Subject: Class II permissive change Request
FCC ID: XVRZON1050

Granted on: 02/05/2017

SCH:

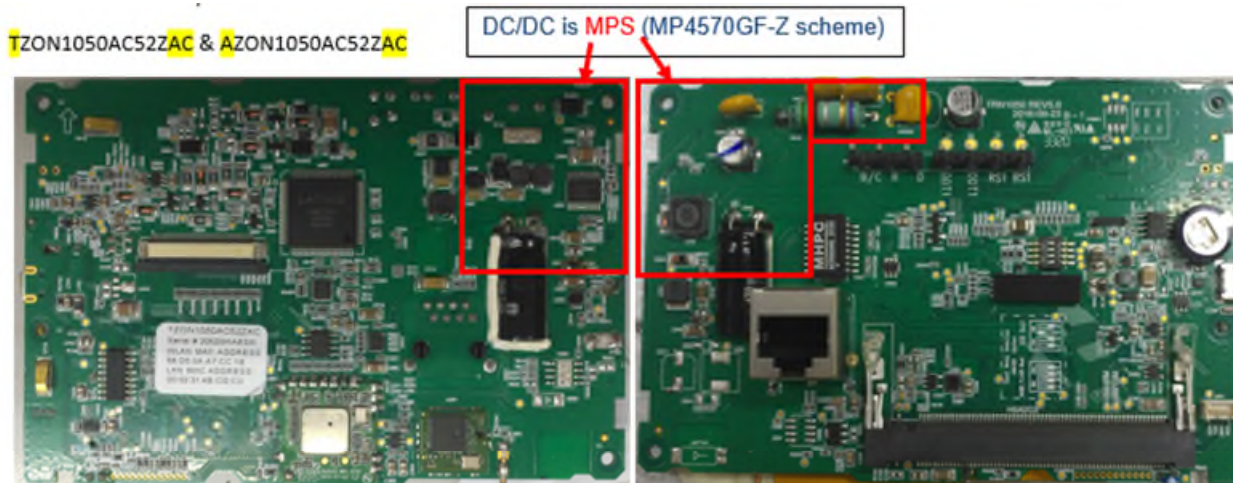
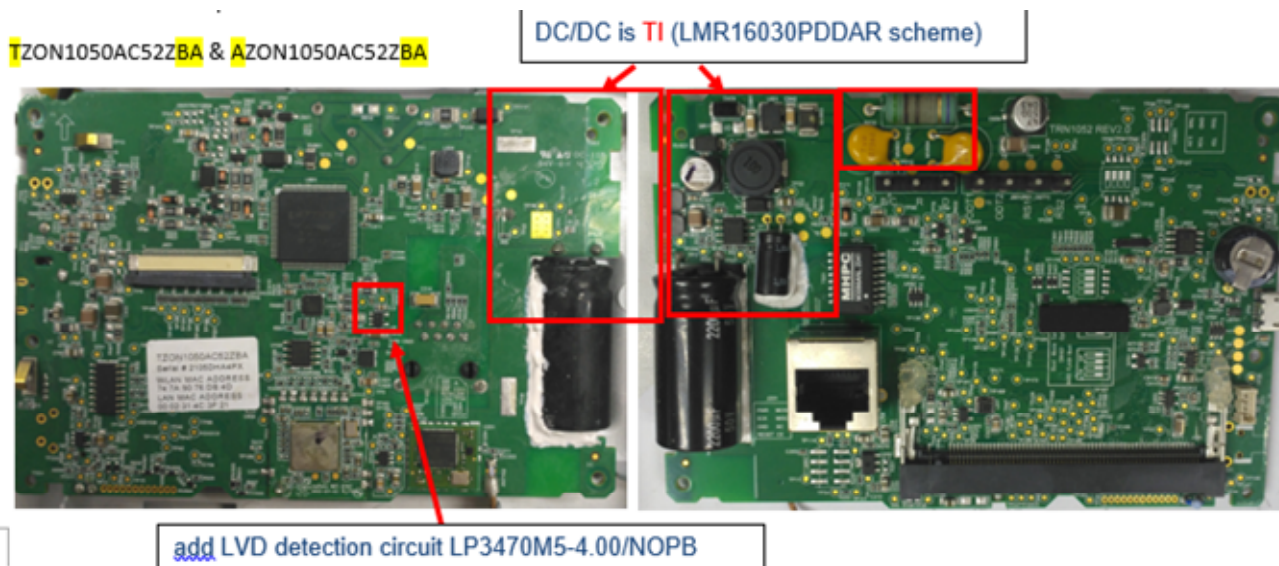
The DC/DC circuit of step down to 5VDC is changed from MPS (MP4570GF-Z scheme) to TI (LMR16030PDDAR scheme). And 5VDC adds LVD detection circuit (LP3470M5-4.00/NOPB).
